# Access Compliance Report Public Rights-of-Way (Curb Ramps)

Main Street: WALLINGSFORD\_RD Cross Street: HEDWIG\_RD Location: NE

ADA ID: RPRK220217155244 Ramp Type: Type 1 - Perpendicular Diagonal Initial Pass/Fail: Pass Overall Compliance: No Severity Score: 22

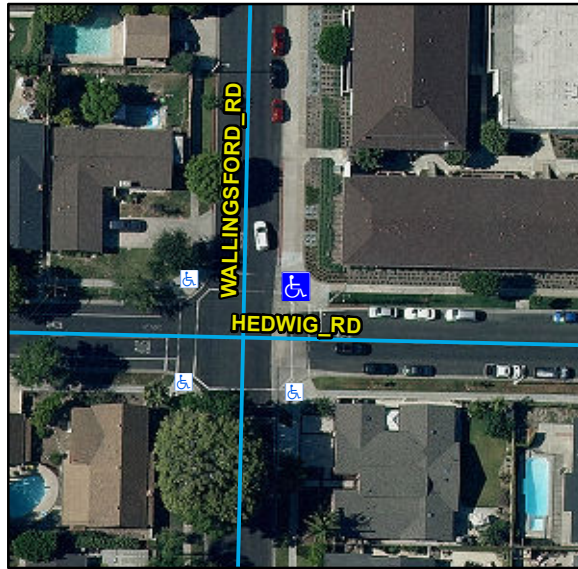
R304.2.1, R304.2.2-Perp, R304.3.2-Para, R304.5.3, R305, STD 1115

Remove & Replace Curb Ramp With Two New Directional Ramps or Equivalent.
